# Access Compliance Report

## Public Rights-of-Way

| Intersection ID: 30336 | Main Street: DULIN_CREEK_BV | Cross Street: FOUR_SISTERS_LN | Location: SE           |
| ADA ID: 29CDBFE3A1A0   | Ramp Type: PerpDiag         | Initial Pass/Fail: Fail       | Overall Compliance: No |

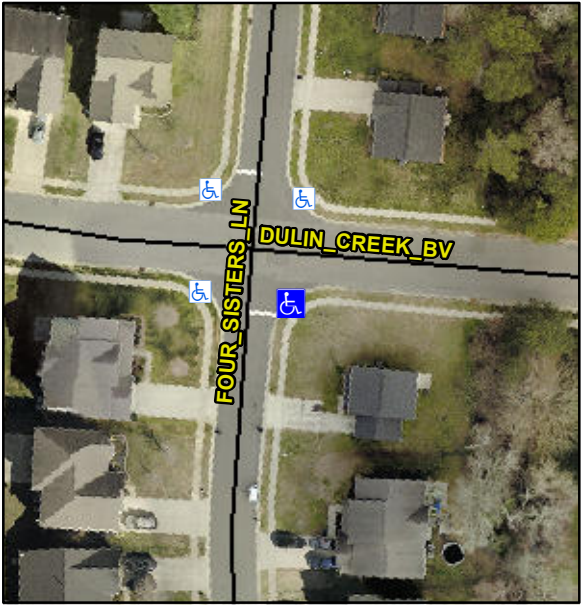
| Codes/Mitigation Info/Possible Solution   |   |  | Field Measurements/Component Compliance |                          |             |
|---|---|--|---|--------------------------|-------------|
|   | <b>Remove &amp; Replace Curb Ramp With Two New Directional Ramps or Equivalent.</b> |  | <b>Yes</b>                              | Ramp Length (in)         | 8.2         |
|   |   |  | <b>No</b>                               | Ramp Width (in)          | 3.6         |
|   |   |  | <b>No</b>                               | Painted X Walk1?         | No          |
| <p>Surveyor Notes:</p> <p><b>N/A</b></p> <p>PROW/ADA:</p> <p><b>Not Found, R304.5.1, R304.5.3</b></p> |   |  | <b>N/A</b>                              | Ramp inside XWalk2?      | N/A         |
